**REPORT OUTLINE FOR AREA PLANNING COMMITTEES****Report No.**

<b>Date of Meeting</b>	26 <sup>th</sup> May 2022
<b>Application Number</b>	PL/2021/09496
<b>Site Address</b>	Land at Dauntseys School West Lavington
<b>Proposal</b>	Development of a coach, mini-bus and taxi drop-off / pick up area and associated infrastructure.
<b>Applicant</b>	Dauntseys School
<b>Town/Parish Council</b>	WEST LAVINGTON
<b>Electoral Division</b>	The Lavington's (Cllr Muns)
<b>Grid Ref</b>	400101 153763
<b>Type of application</b>	Full Planning
<b>Case Officer</b>	Ruaridh O'Donoghue

**Purpose of Addendum Report**

Below is the proposed plan of the scheme.

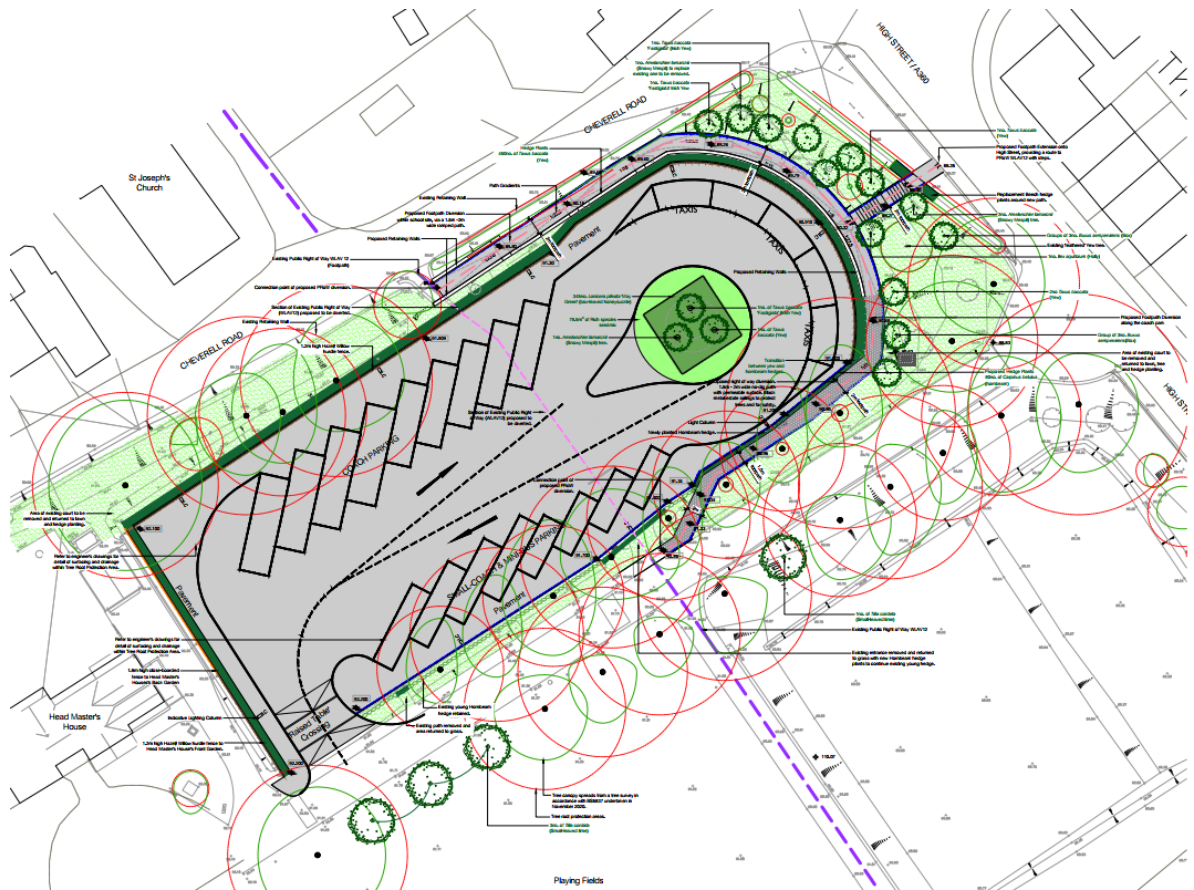
- The mild tweaking of the proposed site plan by the school fails to address the principal problem with the proposal that of access onto the a360 by large coaches at peak times in both directions close to a crossroads and pedestrian crossing.
- The school fail to mention that all deliveries will continue to be made to the rear of the school by vehicles that are the same size as a school bus.

- It is still not believed that a school bus could navigate the turning circle and if taxi's are waiting in their reserved spot then it would become impassable for a full sized coach.

- There will not be a 100% increase in the number of coaches using the main entrance. Currently there are 14 vehicles (a combination of coaches, midi coaches and minibuses) that enter the school via the main drive and exit the school onto the B3098. If coaches now exit onto the A360 as well as arrive via it, this means there will be 28 coach movements now i.e., a 50% increase. It is the opinion of the LHA that these 14 extra movements onto the A360 will not have a detrimental impact upon the users of this highway.

Below is the proposed plan of the scheme.

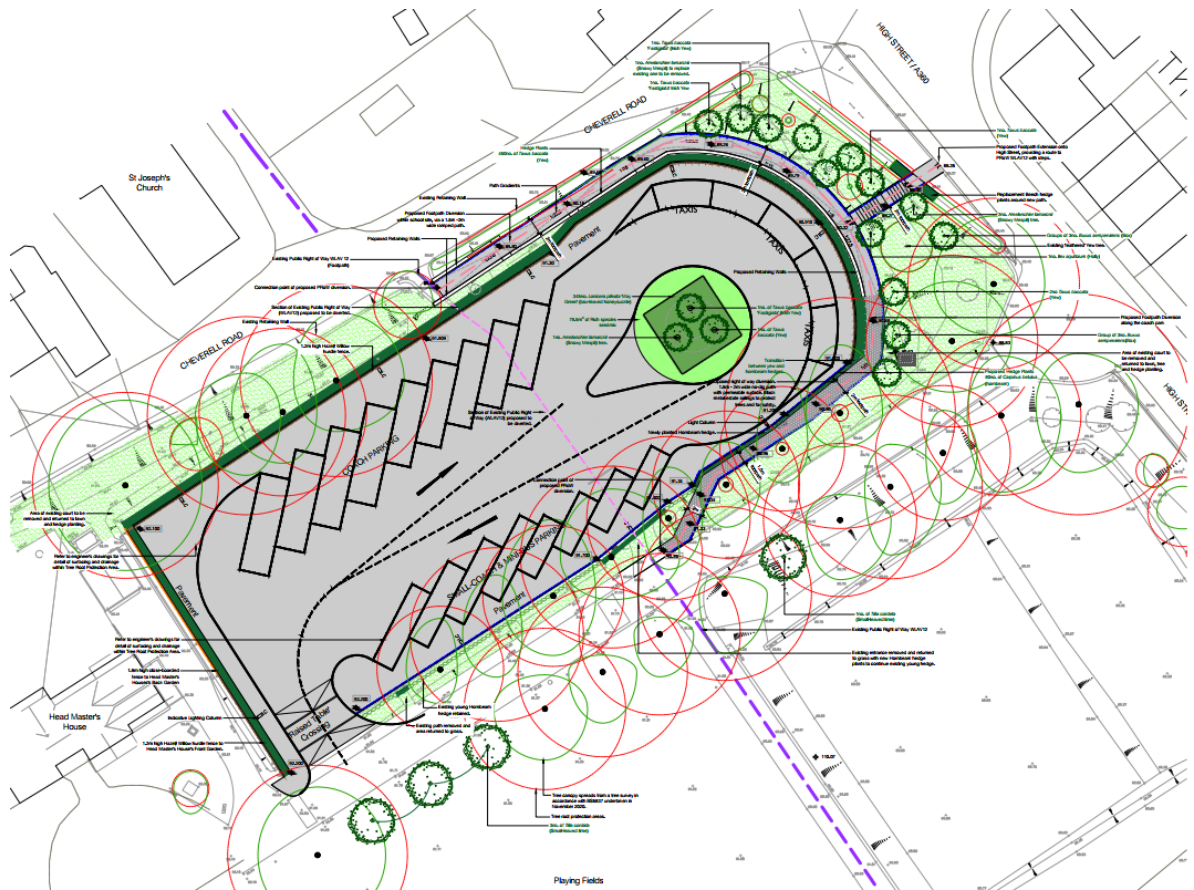
I am happy to withdraw my objection based on the revised plan submitted (2008, 2100, G). The proposed footpath diversion is acceptable to the specification shown in this drawing. A diversion order must be applied for, made and the new route constructed and certified prior to any works taking place which will affect the original route of the footpath. The additional section of path to be dedicated between the site and the High Street can be included on the diversion application as far as the site boundary. The final section of this path circled in red below is situated on highway verge so this section will not need to be dedicated but will need to be constructed under a Short Form S278 agreement as advised by Highways (Hannah Jones).
